Product Change Notification: P-19-017165

Micro K relay components using regrind LCP material

Micro K relay components using regrind LCP material

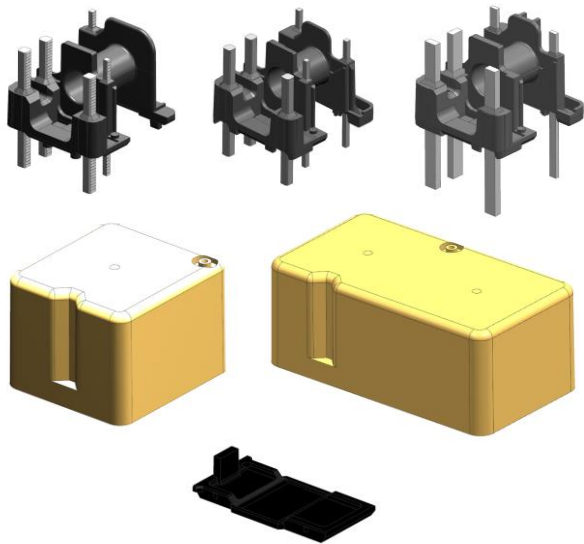
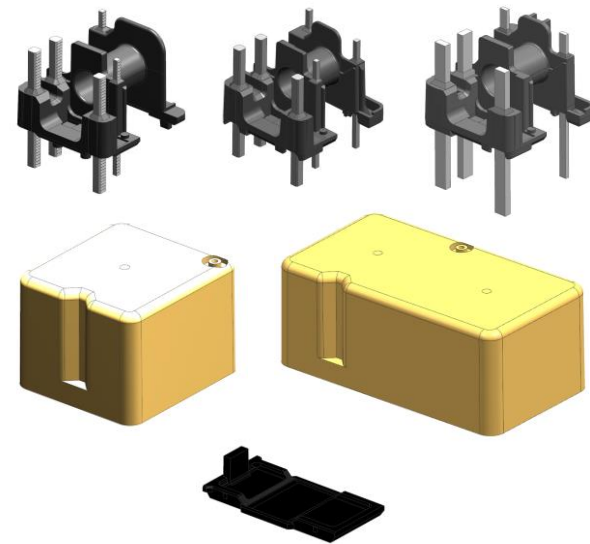
Implementation of the usage of regrind in closed loop for Micro K relay components using LCP material. This process will help reduce the component environmental footprint.

Status old:

Material: LCP GF 30%
Supplier: Celanese
Supplier grade: Vectra E130i (Virgin)

Status new:

Material: LCP GF 30%
Supplier: Celanese
Supplier grade: Vectra E130i (25% Regrind)
